TIMBERLANE WOODS SUBDIVISION

APPLICATION NUMBER 11 DATE August 16, 2007

REQUEST Subdivision

DETAIL SITE PLAN

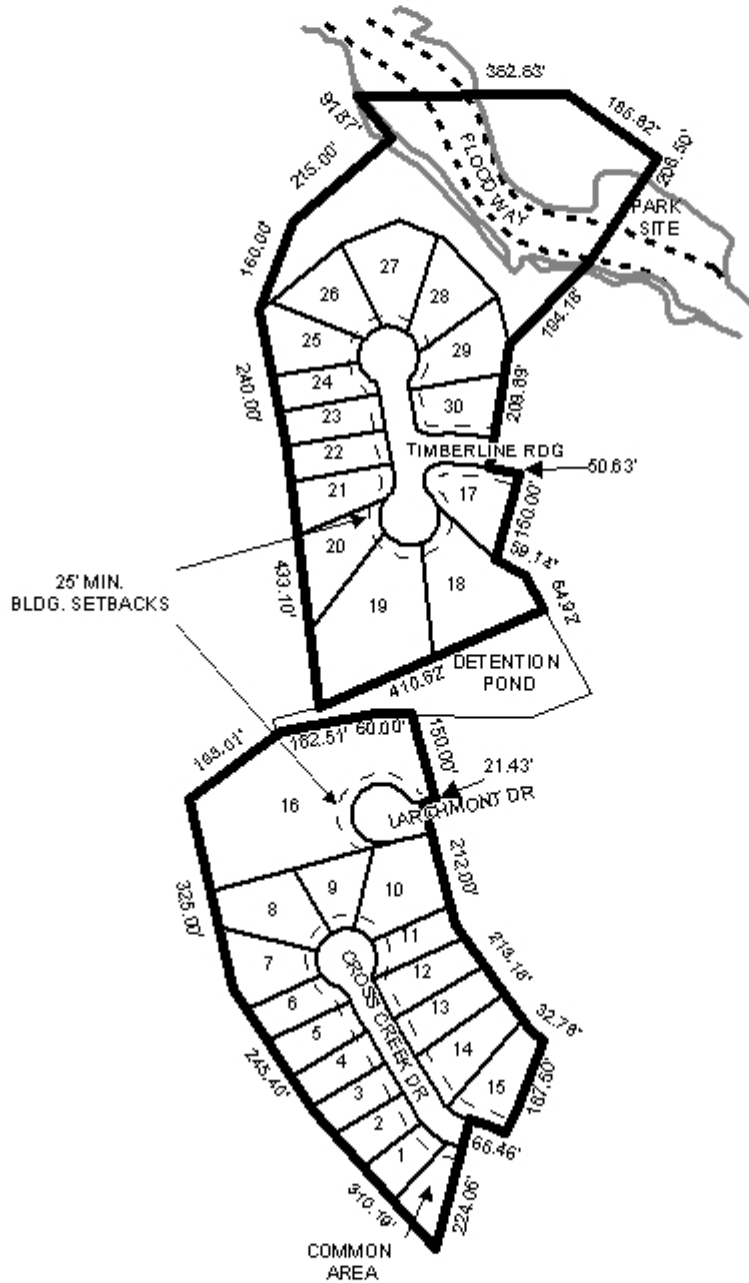
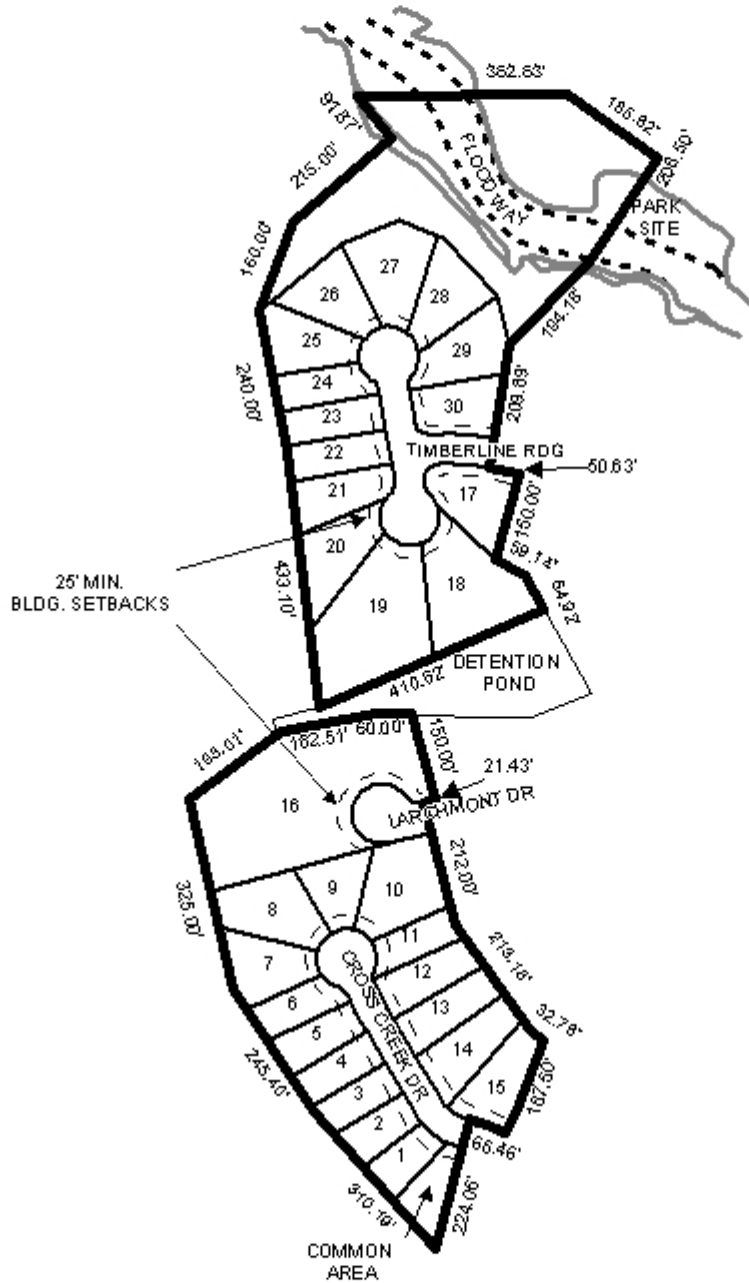
The proposed Lot 16 is a flag-lot. There are no other flag lots in the area of the proposed subdivision, and therefore, this lot should be revised to comply with Sections V.D.2 and V.D.3 of the Subdivision Regulations. The proposed Lot 1 does not appear to comply with Section V.D.2 of the Subdivision Regulations in that it appears to have 57' of public right-of-way frontage and appears to only be 6,954 square feet in size. As such, the proposed Lot 1 should be revised to comply with Section V.D.2. Several lots are missing dimensions, and none of the lots denote their square footage. The plat should be revised to show all dimensions and sizes of all lots (or a table showing lot size should be provided).

There appears to be a common area to the South of Lot 1, however, it is not labeled. The plat should be revised to denote all common areas as such. Further, the 25-foot minimum building setbacks are not shown, and should be depicted.

It appears that the cul-de-sac extension for Cross Creek Drive will result in a closed-end street approximately 850 feet long, exceeding the 600 feet recommended by Section V.B.6. of the Subdivision Regulations. It appears that it could be possible to link Larchmont Drive and Cross Creek Drive and eliminate the two respective cul-de-sacs. It should also be pointed out that the proposed cul-de-sac length and the diameter of the cul-de-sac will not meet the minimum requirements of the 2003 International Fire Code, as adopted by the City of Mobile and the Mobile Fire-Rescue Department. Therefore, the design of the cul-de-sac and the turn around areas should be reassessed, and the applicant should certify that the design will comply with the requirements of the 2003 International Fire Code, as adopted by the City of Mobile.

A detention pond is depicted on the plat, however, no access via easement is provided as a part of this development. The applicant should submit evidence that a drainage access easement is available through adjacent units of Timberlane, or provide such an easement as a part of the subdivision at hand.

- 1) The labeling of all common areas, including detention areas, and the placement of a note on the plat stating that the maintenance of all common areas and detention areas is the responsibility of the property owners;*

- 2) Provision of evidence of a drainage access easement to the detention area being available through another unit of Timberlane, or provision and depiction of such an access easement as part of this subdivision;*

- 4) Placement of a note on the plat stating that each lot is limited to one curb-cut each, with the size, design and location to be approved by Traffic Engineering and to comply with AASHTO standards;*

- 5) Certification that cul-de-sac length and design meet the minimum requirements of the 2003 International Fire Code, as adopted by the City of Mobile.*
